To: T10 Technical Committee  
 From: Rob Elliott, HP (elliott@hp.com)  
 Date: 30 January 2005  
 Subject: 04-370r3 SAS-1.1 Merge IT and IR with XT and XR

### **Overview**

Figure 12 — Deriving a receiver device jitter tolerance eye mask at IR, CR, or XR

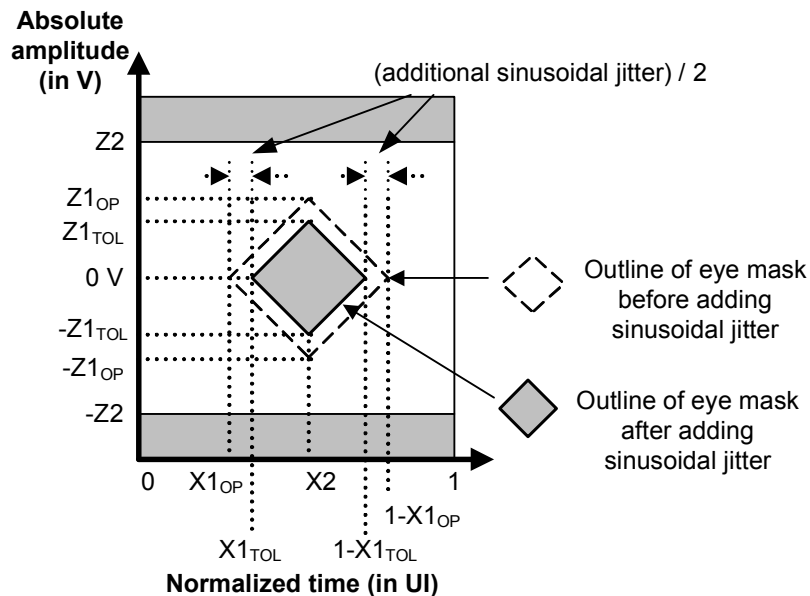
Figure 12 describes the ~~receive tolerance eye masks at IR, CR, and XR and eye mask used to test the jitter tolerance of the receiver device at IR and CR.~~ Figure 12 shall be constructed using the X2 and Z2 values given in table 4. X1<sub>OP</sub> shall be half the value for total jitter in table 8 and X1<sub>TOL</sub> shall be half the value for total jitter in table 10, for applied sinusoidal jitter frequencies above ((bit rate) / 1 667).
